**PLANNING COMMISSION STAFF REPORT  
MAY 17, 2018**

**AGENDA ITEM 7.C File No. PL16-0054 – TRINITAS MIXED USE PROJECT**

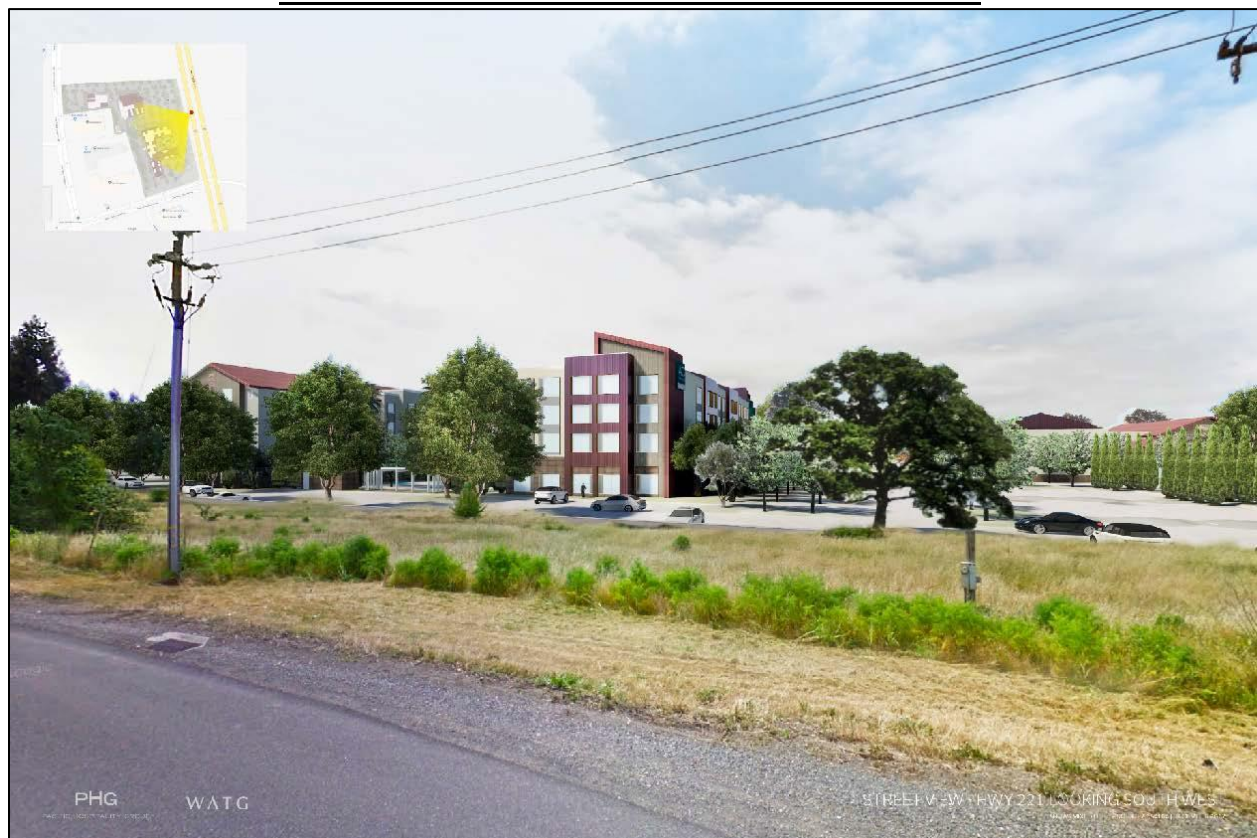
**Site Plan/Building Arrangement:** At the Planning Commission Preliminary Review in June 2017, the Commission discussed that the primary site entry places visitors and hotel guests toward the rear of the project, raising wayfinding and design concerns. The Applicant has worked to address these issues by enhancing the “wayfinding” signage, by adding decorative paving at the main vehicular entry to lead guests in the direction of the hotel lobby entries (see Sheet A0-03), and by adding architectural details to the rear (west) elevation. While Staff supports the proposed use of decorative paving to assist in wayfinding, Staff recommends the use of additional decorative paving to assist in guiding patrons to the AC Hotel entry. A condition has been added to this effect (see Condition #18). The building arrangement has the benefit of allowing for a strong pedestrian connection between the hotel building and the winery, which was noted at the Preliminary hearing. A drawback of this site layout is that there is a significant amount of project parking between SR 221 and the proposed hotel and winery buildings, where it is potentially highly visible from SR 221. The screening of this parking is addressed in the landscaping discussion that follows in this report.
